SUBJECT: NRC INSPECTION REPORT 05000461/2006011(DRS); PRELIMINARY
GREATER THAN GREEN FINDING FOR CLINTON POWER STATION

Report No: 05000461/2006011(DRS)

IR 05000461/2006011(DRS); 03/06/2006-11/17/2006; Clinton Power Station; Component Design Bases Inspection.

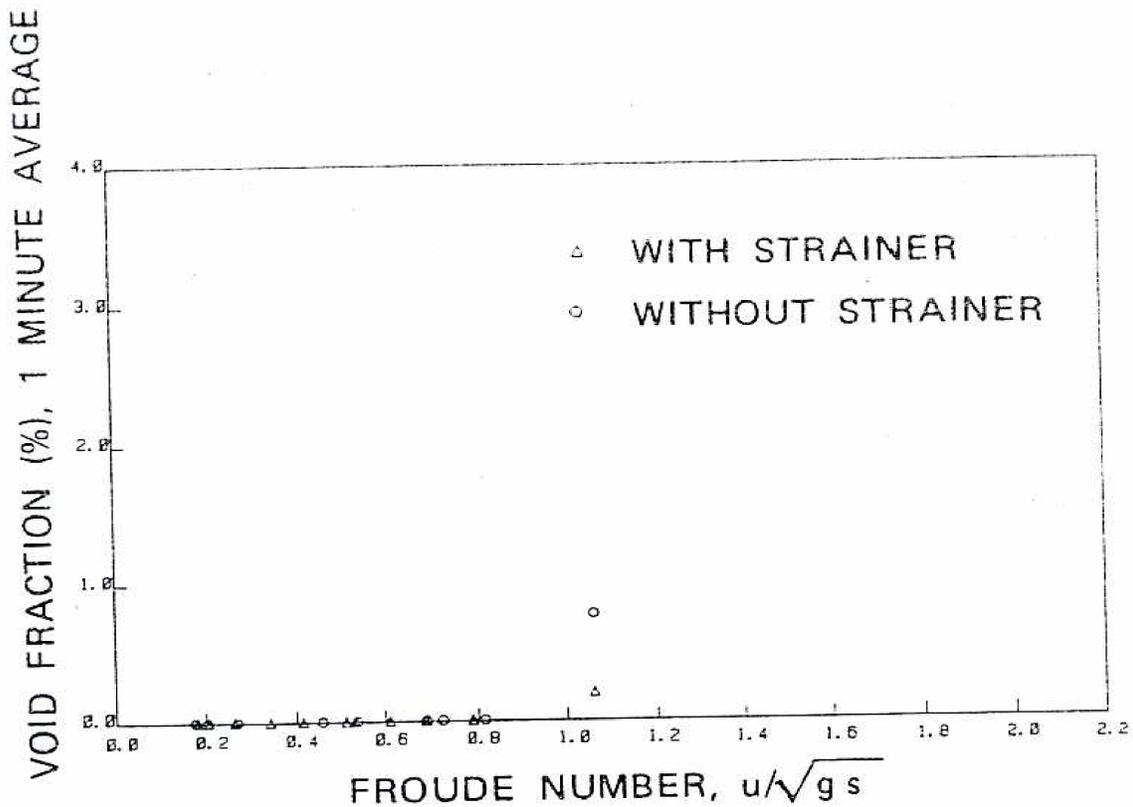
4. To further justify the acceptability of extrapolating beyond the experimental 2 percent or more (by volume) air entrainment, the licensee determined the Froude number based on submergence and compared that result against Figure 13.b of NUREG/CR-2772. The inspectors did not agree with this approach for the following reasons:

- a. The licensee determined that the Froude number (if determined from submergence instead of diameter of the pipe) was 1.84 at the predicted 2 percent air entrainment. The licensee plotted this point in Figure 13.b and concluded that since this point was well below a straight line (developed by the licensee), the void fraction did not increase as fast as the Froude number. The inspectors disagreed with the basis for the licensee's conclusion because the licensee did not provide justification for assuming a linear relationship between points (0.8, 0.0) and (1.06, 0.8) from the figure (the experimental data did not indicate or predict a linear relationship with respect to increasing Froude number and void fraction).

- b. The licensee determined that the onset of air entrainment would occur at about 16 inches above the centerline of the pipe. The inspectors determined that the Froude number (based on submergence and a flow rate of 5880 gpm) for the onset of air entrainment would be about 1.66. With a Froude number this large, Figure 13.b would predict air entrainment of at least 0.8 percent - at least the same as that found in the experiment. Using the figure in this manner and assuming the linear relationship as described above, showed that predicted onset of air entrainment was not conservative.

- c. The inspectors noted that Figure 13.b of NUREG/CR-2772 plotted the Froude number and void fraction observed during a series of tests. The data showed that at a constant submergence (measured from the centerline) of 24 inches for a 24 inch diameter horizontal inlet, a void fraction of 0.8 was measured for a Froude number of 1.06. Because the data was derived for a specific configuration, the inspectors concluded that its use for other submergence values may not be applicable.

- d. The inspectors applied the point (Froude = 1.06, Void Fraction = 0.8) (the experimental data in NUREG/CR2772) to those equations used by the licensee. Assuming a pipe diameter of two-feet (conservative to assume the inner diameter is equal to the outer diameter), the inspectors determined the Froude number remained at 1.06. Applying the equations developed by Sanders, et al, the inspectors determined that the onset of air entrainment was predicted to occur at 33 inches from the bottom of the pipe or 21 inches from the centerline. This prediction significantly contradicts the observed data obtained in the NUREG where air entrainment was actually observed at 24 inches above the centerline.

Similarly, the inspectors determined the formation of a vortex using the equation derived by Kubie described in IP-M-0384, Revision 1B for the data point from Figure 13.b of NUREG/CR-2772. The inspectors calculated that a vortex would form at about 26 inches above the centerline of pipe. This result is not consistent with the observations from the Sanders, et al study which concluded that vortices formed at water levels significantly higher than the onset of air entrainment. Although the predicted formation of a vortex (26 inches) and the predicted onset of air entrainment (21 inches) differ, the actual results from NUREG/CR-2772

showed 0.8 percent of actual air entrainment very close to the predicted formation of a vortex (24 inches compared to 26 inches). Therefore, the inspectors concluded that based on the significant differences in the predicted and observed data, it appeared that the actual minimum submergence which results in the onset of vortex formation, was likely dependent upon the physical arrangement of the system. Therefore, anything less than a conservative bounding submergence level appeared to need site specific testing or a closer correlation to support a more realistic value.

The licensee drew a straight line from point (0.8,0) [without strainer] to (1.06,0.08) [without strainer] and used this linear relationship in their evaluation.
